# SAFETY RECALL NOTICE

**Re: Reverse Actuator – Can Am™ Spyder™ RT SM5 roadster**

## SAFETY CAMPAIGN

Subject: **Spyder™ RT SM5 Reverse Actuator**

DESCRIPTION	P/N	QTY
Reverse actuator assembly	(P/N 710 001 954)	1

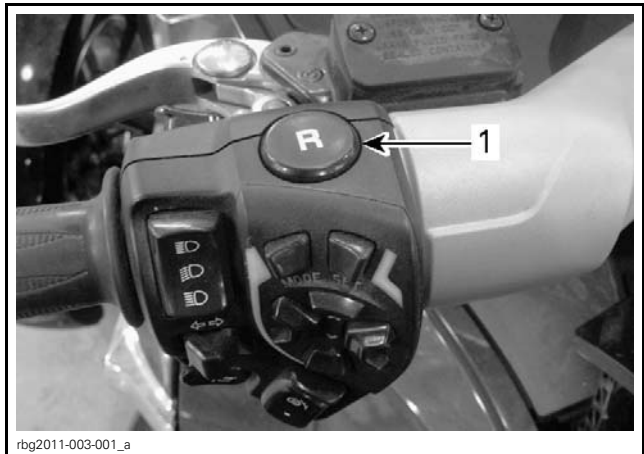
Validate proper operation of the reverse actuator. If defective, replace the reverse actuator assembly.

NOTE: Replace **ONLY IF** part is found defective. Order through regular channels.

A.  $37\text{ mm} \pm 1\text{ mm}$  ( $1.46\text{ in} \pm .04\text{ in}$ )

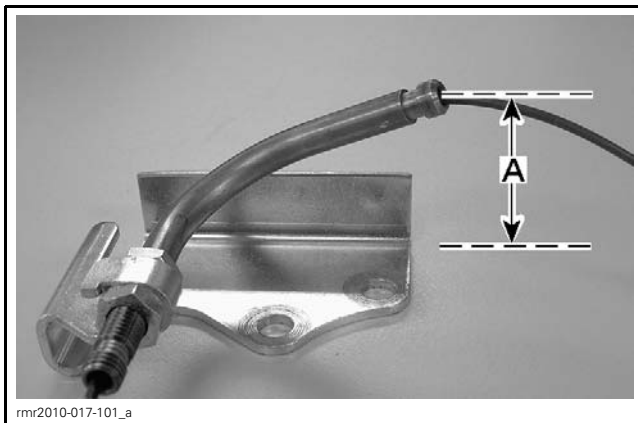
- Set the distance between the workbench surface and the cable guide center line to  $37\text{ mm} \pm 1\text{ mm}$  ( $1.46\text{ in} \pm .04\text{ in}$ ) as shown, then tighten the upper adjustment screw.

**ACTUATOR AND CABLE GUIDE IN LINE**

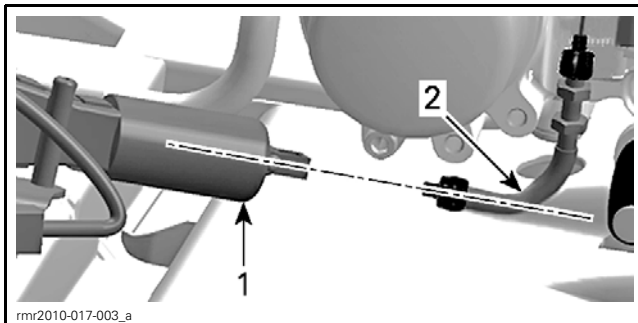
- Install the cable guide bracket on the engine.
  - Position actuator on the frame member, then start the rear mounting bolt.
- The actuator center axis must be in line with the cable guide vertically.

- Place enough shims (P/N 710 002 024) underneath the actuator mounting plate front hole to obtain alignment.

A. Free play at the actuator rod

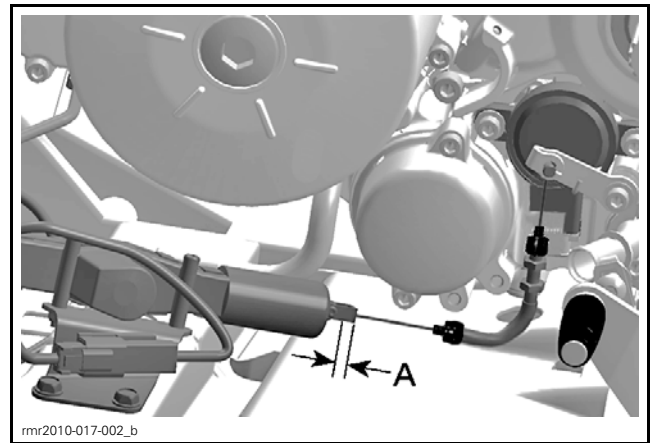
- Tighten mounting screws.
- Make sure that there is an axial free play of  $2\text{ mm}$  ( $1/16\text{ in}$ ) minimum at actuator rod.
